Notice of Modification

Section 96(2) of the Environmental Planning and Assessment Act 1979

The development consent (SSD-4960) for the Bulga Optimisation Project, granted by the Planning Assessment Commission on 1 December 2014.

Proposed Modified Development

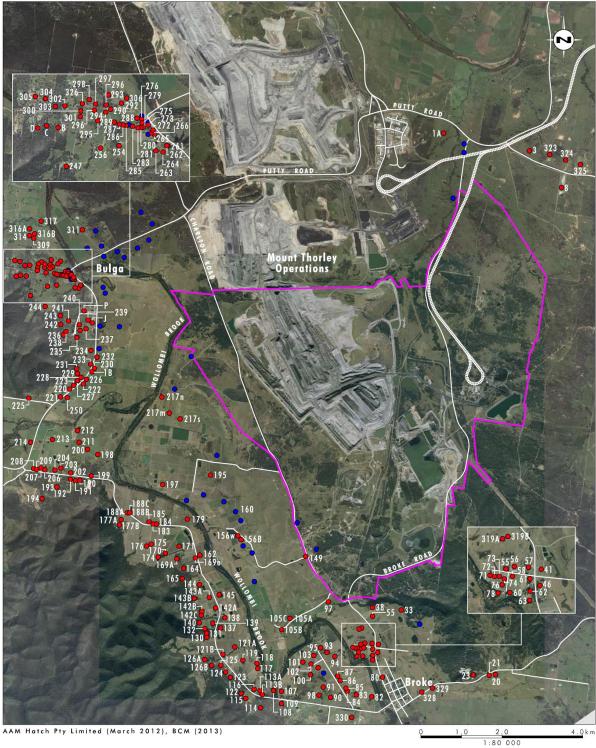
32. Delete the Figure in Appendix 2 Development Layout and replace with the following:

Location of Properties Included in Noise Assessment

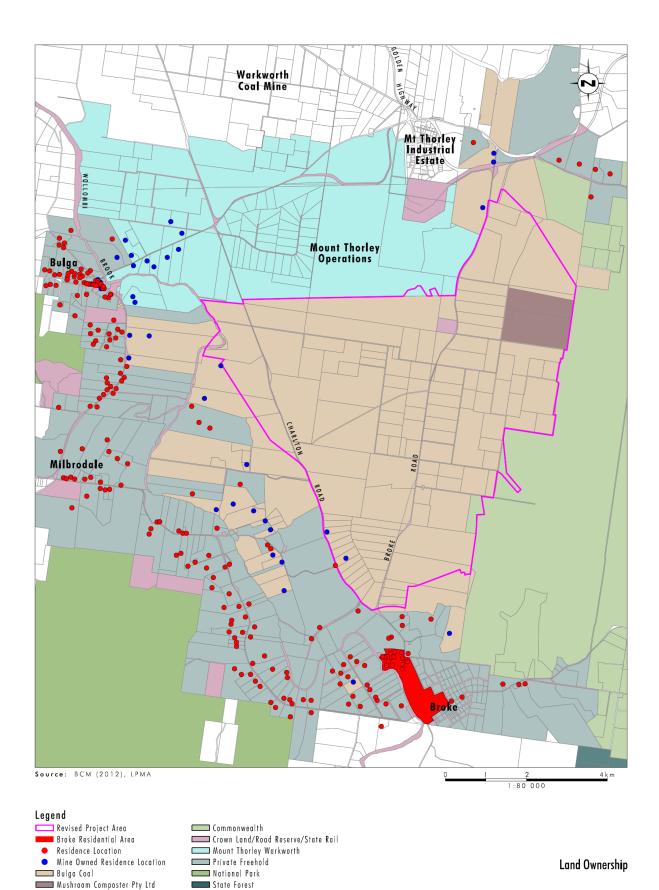
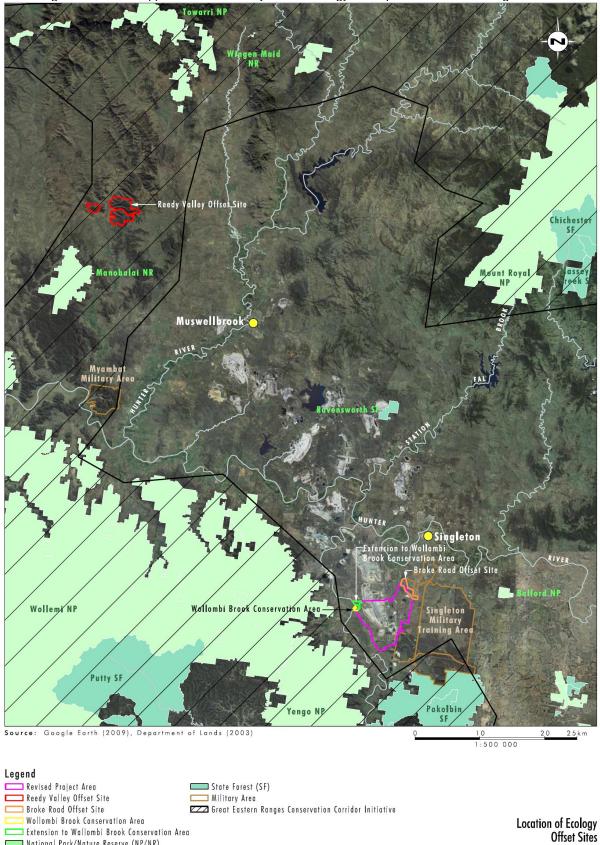
33. Delete Figures 1 and 2 in Appendix 5 Land Ownership and replace with the following:

Proposed Broke Road Offset Site

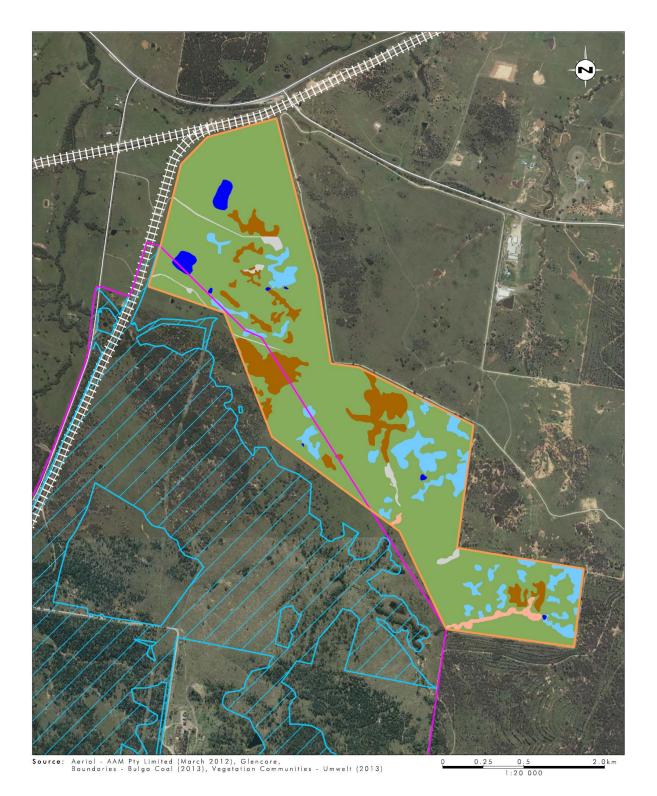
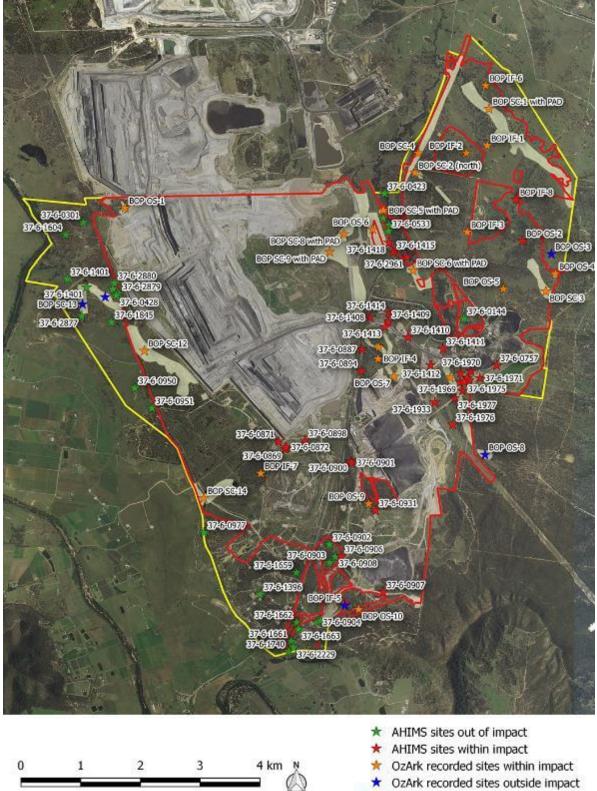
File Name (A4): 2869_1041.dgn 20161214 13.01 34. Delete Figures 1 and 3 in Appendix 9 Biodiversity Offset Strategy and replace with the following:

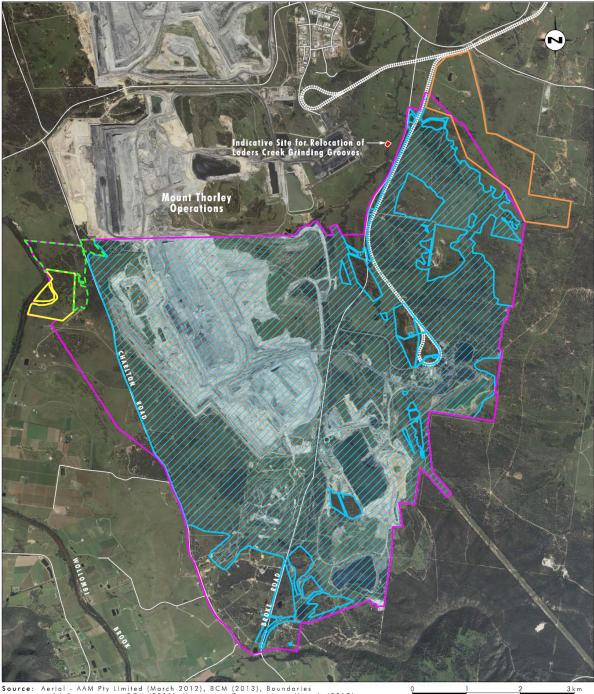
a) delete Figure 1 and replace with the following:

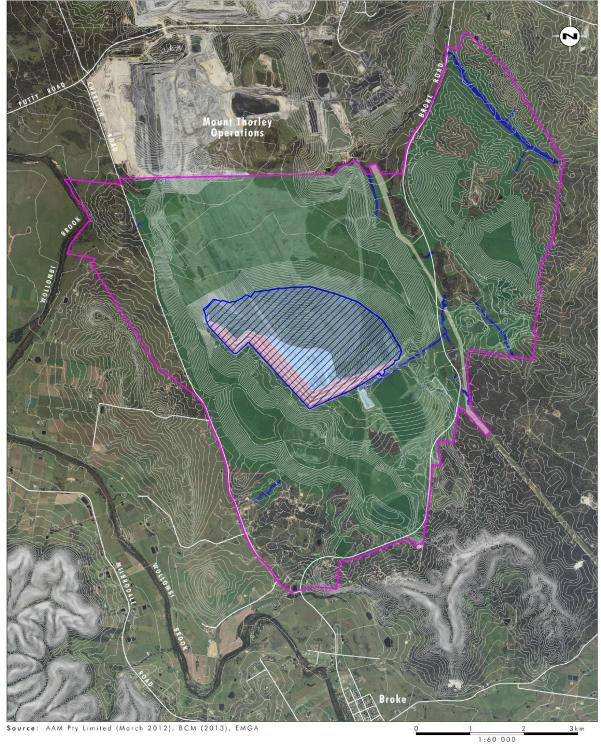
d) delete Figures 3 and 4 and replace with the following:
